#	SOW Reference	Question	Answer A/E- GOV- CO
1	Specifications,	Can the Superintendent, SSHO, QC be held	Yes. See 01 35 26-13, 01 45 00-2
	Div 01	by the same person or can they dual-hatted in any combination?	
2	Specifications,	Please confirm if any training requirements	VA PIV Card requirements are listed at
	Div 01	(other than OSHA) are needed to be	https://www.osp.va.gov/How_To_Get_A_VA_ID_
		completed as part of the VA badging	Badge.asp
3	Staging	process.	Ct Cloud V/A response See "Staging Darking
3	Staging - Parking Area	Will power be provided to the primary staging area location noted for an office trailer?	St Cloud VA response. See "Staging - Parking Area" document
4	SOW	Please confirm the building access points	St Cloud VA response. See "Staging - Parking
		and routes for construction personnel and	Area" document
_		materials at B48 and B51.	
5	51-AE-110	Sheet 51-AE110 is noted "this is not accessible" at toilet in room 128A. Is this	Omit note. Design was approved with a toilet that does not meet VA Barrier Free Accessibility

Item 53 – S.E.A.L. style interior window

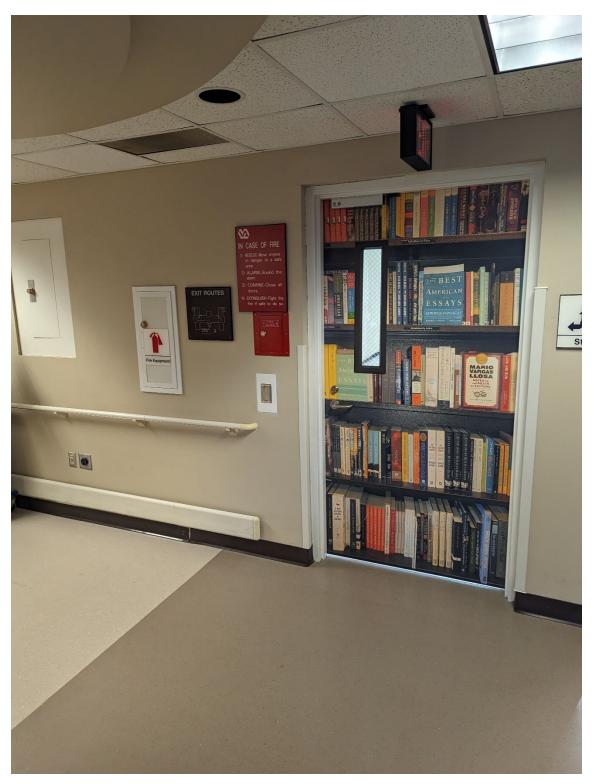
51	AW600	Drawing shows a sign message schedule.	See VA Signage Design Manual PG-18-10,
01	/ 11000	Location 130 calls for a sign type IN-1.10.	Section 3.2.
		Can the A/E add the detail for this sign type?	
50			Details 12/AFEE0 and 1/DE00 apply to show an
52	51-AD111	Note DE23 calls for partial removal of	Details 13/AE550 and 1/P500 apply to shower.
		concrete deck for shower pan. No	See revision
		information except location is shown on the	
		structural drawings. Can the A/E provide a	
		detail that shows what needs to be removed	
		and how much?	
53	Keyed Notes	FL5 - INSTALL SALVAGED S.E.A.L. STYLE	Photos provided
	51-AE111	WINDOW - Can the VA provide a photos of	
		this?	
54	Key Notes	DE28 - SALVAGE FOR REUSE. REMOVE	See question 53
	51-AD111	INTERIOR SECURITY WINDOW TO	•
		ACCOMODATE PLAN. SEE FLOOR PLAN.	
		PREPARE EXIST EXTERIORWINDOW	
		FOR BLACKOUT FILM AND OPENING FOR	
		INFILL Can VA provide photos of this

security window? On sheet 51-AE113 does	
		not show any window going back in what	
		does the VA plan on putting back? Detail 14 on Sheet AE550 also does not show	
		anything new going back in.	
55	Key Notes	DE 29 - SALVAGE FOR REUSE.	Photo provided
	51-AD111	CAREFULLY REMOVE FIRE ALARM	
		SECURABLE PULL.SEE FLOOR PLAN	
		Can VA provide photos of these?	
56	Key Notes	DE 30 - SALVAGE FOR REUSE.	Photo provided
	51-AD111	CAREFULLY REMOVE FIRE ALARM	
		SECURABLE FIRE EXTINGUISHER	
		CABINET. SEE FLOOR PLAN Can VA	
		provide photo of this?	
57	51-AE110	Exterior walls do not show any new walls or	See General Note 8 on 51-AE111
0,		patching. Should we be assuming these	
		walls need to be repaired after demo?	
58	Spec 10 22 13 -	Part 2.2 A 1 calls for wire mesh to be placed	See question 30
00	•		
	2	on the face of gypsum wallboard west and	
		south walls on Room A200 for Building 01.	
		During the site walk we were not taken to this

64	51-EF110 51-EF111	drawing shows black mark near all the beds but has no information on what it is. Can you please provide information on what the black marks are?	Black marks removed as they are Med Gas information shown from Linked Revit model.
65	E300	The Electrical riser diagram shows the new panel 51-L1-2 being fed from 51-MDP and than feeding 51-L2-2. Can you please provide information on the location of the two existing panels and the distance required for the new conduit and cable?	51-MDP is on plan west wall of Mech 15 on sheet 51-EE100 approximately 120'. 51-L2-2 is located above demolished 51-L1-2 approximately 55' from new panel 51-L1-2.
66	Specifications, Div 01	Can SSHO and QC be on any other projects during the construction of this project?	See question 1
67	51-AD111	There is a window between grid H and I on grid 1 that has red dashed lines on it with no note. Please confirm if this window is to be demoed and a new window installed?	Window remains. Prepare to install salvaged S.E.A.L. window floor plan keyed note FL5.
